## Affinity Water's response to Accelerated infrastructure delivery project: draft decisions

We welcome the publication of Ofwat's draft decisions on accelerated funding schemes and are pleased to see a number of our proposed schemes are assessed to have met the criteria. We are confident that the acceleration of this funding will enable us to deliver greater value and resilience to our customers

**Figure 1 - Connect 2050 optioneering process**

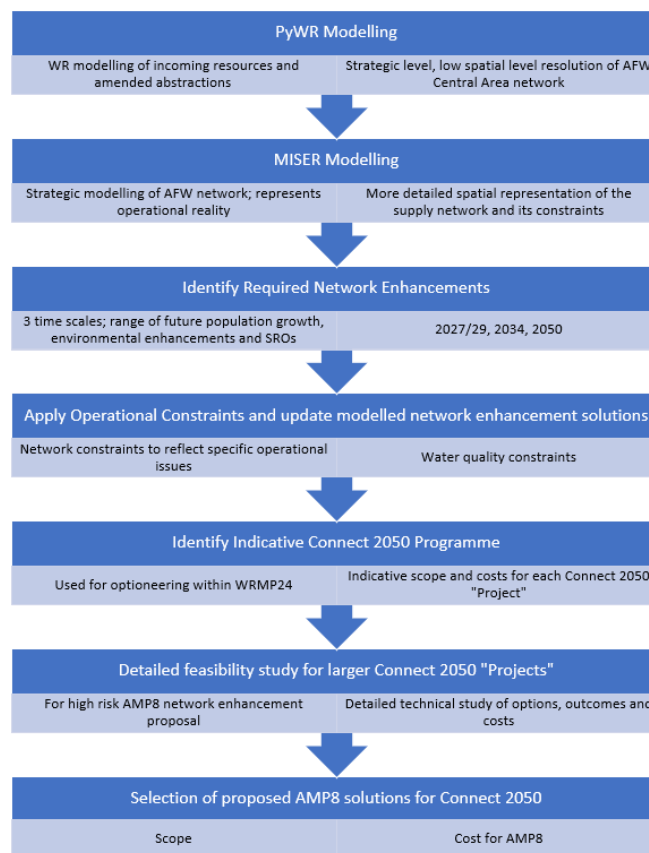
- i. These schemes are preferred solutions in dWRMP24 however we have raised concerns about Affinity Water's dWRMP in our consultation response including concerns relating to options sufficiency meaning we do not have full confidence it represents the best option. There are complex dependencies between Affinity Water schemes 1-5 which raise some concerns about the outputs each would achieve. Although the options appear to have a low unit cost it is unlikely that this can be realised independently of the other schemes proposed. Supporting schemes AFW 1-5 would significantly raise the unit cost which does not give us confidence to support this option for acceleration.

The Connect 2050 programme has been derived using a holistic, tiered approach of extensive modelling and options appraisal. This is illustrated in Figure 1 below.

The PyWR and MISER modelling was undertaken across a wide range of scenarios – identifying the optimum combination of solutions that resolved the full range of scenarios. Ultimately, the MISER modelling, which provides an operationally realistic representation of the AFW network, was used to determine if any of AFW's supply zones are showing deficits of supply under any of the scenarios. Enhancement solutions could then be developed to address any such supply shortfalls. If other zones are in surplus, but the existing supply network is at capacity, then infrastructure can be identified to link up the areas of surplus water with those which are in deficit. The scenarios considered in developing this optimum solution set included:

**Figure 3 – Forecast impact of climate change on mains burst rates**

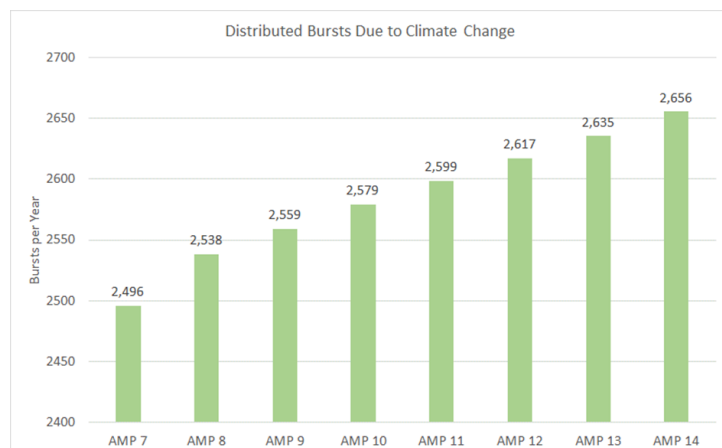
**Proposal to install 662 new pressure reducing valve (PRV) controllers and 37 new PRVs (with intelligent controllers). Company states that this will deliver 238 less main repairs and 0.5MI/d leakage saving by 2025-26. Proposed scheme only has partial alignment with the company's dWRMP24 demand management option. The leakage unit costs are very high so some concerns as to whether this is the best option. The company is outperforming on its PR19 mains repairs performance commitment, meaning some concerns about need for investment requiring additional funding from customers to do more.**

Our dWRMP demand management option is being updated and will accurately reflect the latest business case for network calming. On an in-AMP unit cost basis, network calming represents a high-cost solution and would hence be cost prohibitive as an in-AMP Base totex leakage option. However, network calming will reduce leakage for the duration of the asset lives of the equipment installed, representing a lower-cost solution over the 25-year period, as outlined per pressure management solutions within our dWRMP. In addition, given the simultaneous benefit to other key performance areas, to achieve best value to customers we do not consider unit cost comparison of a single metric in isolation when considering whether this is the best option.

Whilst the company performed well in 2021/22 period against the PR19 target, this performance is highly variable due to the exogenous impacts of weather, meaning in-year performance levels is not a good indicator of underlying conditions or future performance. Modelling indicates the impact of climate change (through changes in weather patterns creating more shrink-swell ground movement in the prevalent clay soils within our region) will significantly increase the rate of bursts in our water network, requiring a step-change investment to offset this. Figure 3 displays the increase from an AMP7 baseline level.
